DUBLIN STREET SUBDIVISION

APPLICATION NUMBER 8 DATE June 6, 2013
APPLICANT Dublin Street Subdivision
REQUEST Subdivision

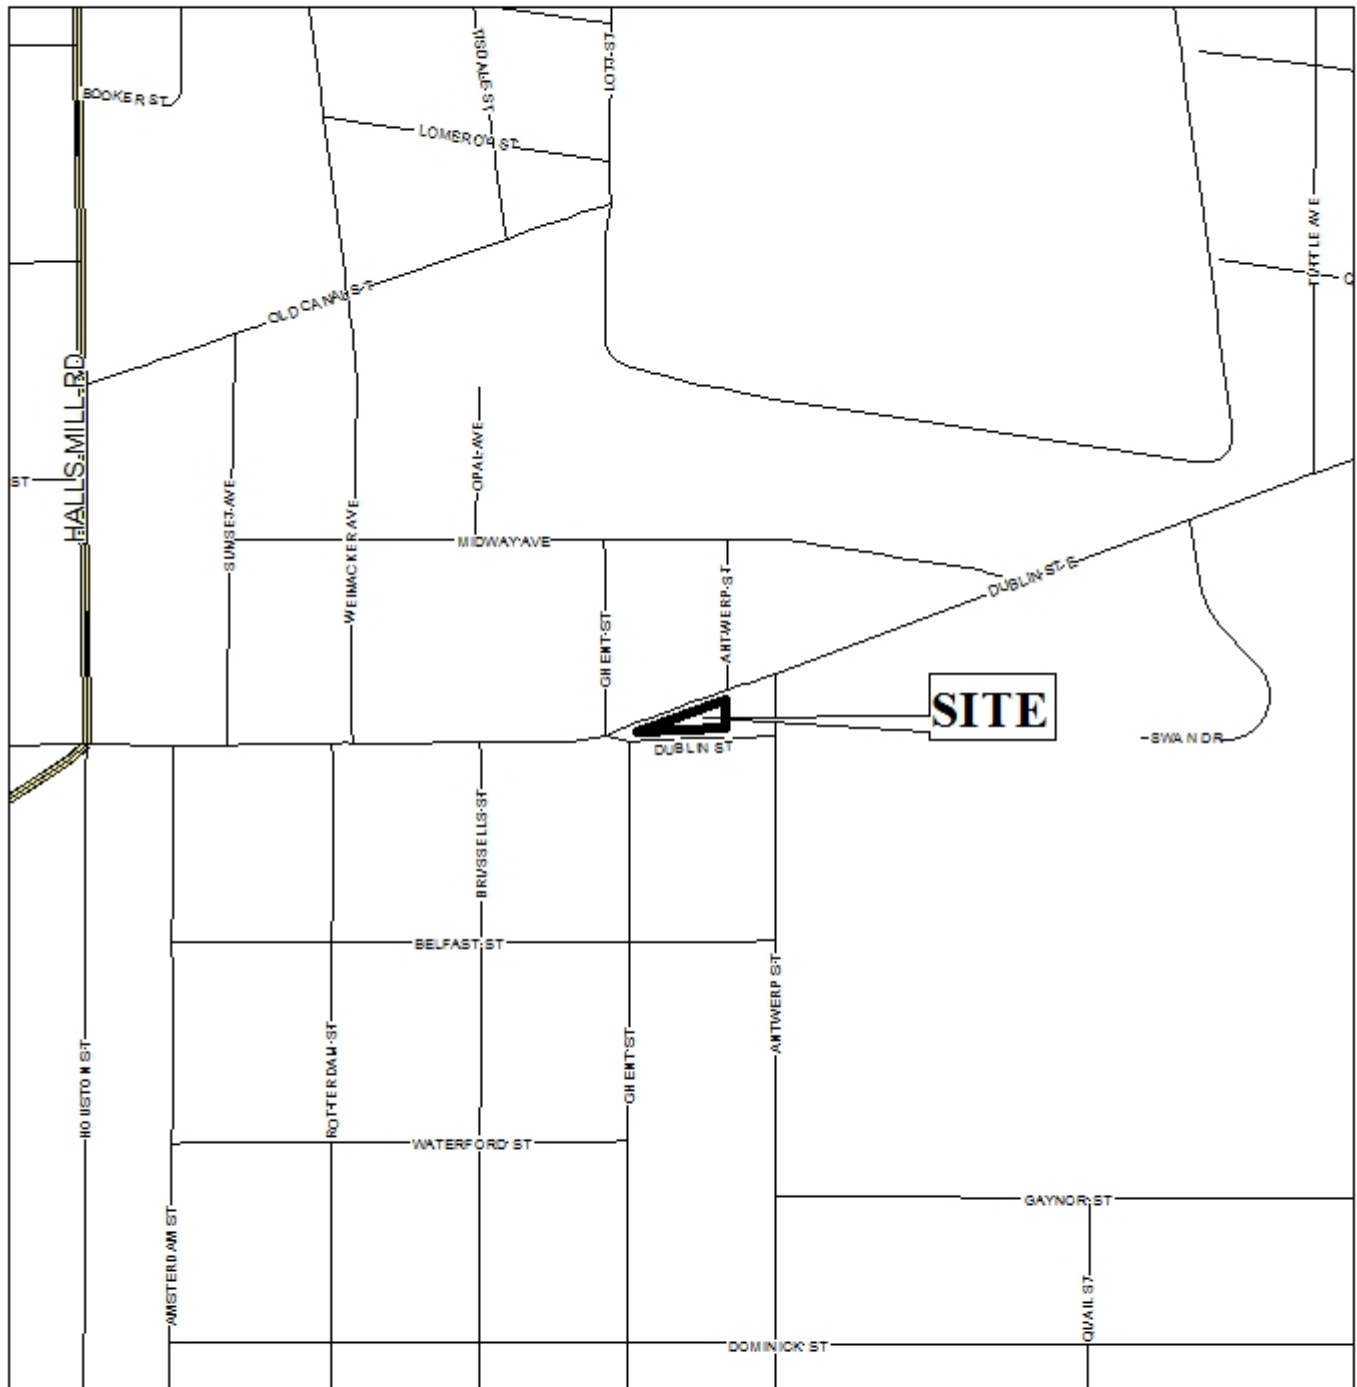
Traffic Engineering Comments: Driveway number, size, location, and design to be approved by Traffic Engineering and conform to AASHTO standards. City of Mobile driveway standards are 24 foot wide with 20 foot radii. Changes must be made to the driveway as shown to meet the standards and eliminate backing into the right-of-way.

The proposed lot, as depicted, does not meet the minimum size requirements as regulated by Section V.D.2. of the Subdivision Regulations. However, as the site consists of portions of smaller existing legal lots of record, a waiver of Section V.D.2. would seem in order. The area of the lot is depicted on the plat, and should also be shown on the Final Plat in square feet, or a table provided on the Final Plat with the same information, if approved. The plat should be revised to indicate the lot size in square feet and acres after any required right-of-way dedication.

The proposed lot has frontages on Dublin Street and Dublin Street East, both minor streets with required 50' rights-of-way but with substandard 40' rights-of-way. Therefore, dedication should be required to provide 25' from the centerline of each street. Dedication should also be required to provide a radius curve at the intersection of Dublin Street and Dublin Street South, with the size to be coordinated with Traffic Engineering and City Engineering.

As a means of access management, a note should be required on the Final Plat stating that the lot is limited to one curb cut to Dublin Street and one curb cut to Dublin Street East, with the size, location, and design to be approved by Traffic Engineering and conform to AASHTO standards.

The minimum building setback lines are not indicated along the street frontages; however, a note accompanying the application indicates a Setback Variance will be sought for a 15' minimum building setback line along Dublin Street. An application for reduced front yard setbacks along both Dublin Street and Dublin Street East is scheduled to be heard by the Board of Zoning Adjustment at its June 3rd meeting; however, the requested setbacks are for other than just 15' along Dublin Street. Therefore, the plat should be revised to indicate the standard 25' minimum building setback lines or whatever setbacks are approved, if approved, by the Board of Adjustment. The setbacks should be measured from the property line following required dedications.

- 1) revision of the plat to label the lot size in square feet and acres after required dedication, or provision of a table on the Final Plat with the same information;

- 2) revision of the plat to provide a corner radius dedication at the intersection of Dublin Street and Dublin Street East, with the size and location to be coordinated with Traffic Engineering and City Engineering;

- 3) placement of a note on the Final Plat stating that the site is limited to one curb cut to Dublin Street and one curb cut to Dublin Street East, with the size, location, and design to be approved by Traffic Engineering and conform to AASHTO standards;

- 4) revision of the plat to illustrate the 25' minimum building setback line along Dublin Street and Dublin Street East, or whatever may be approved by the Board of Zoning Adjustment, measured from any required dedications;
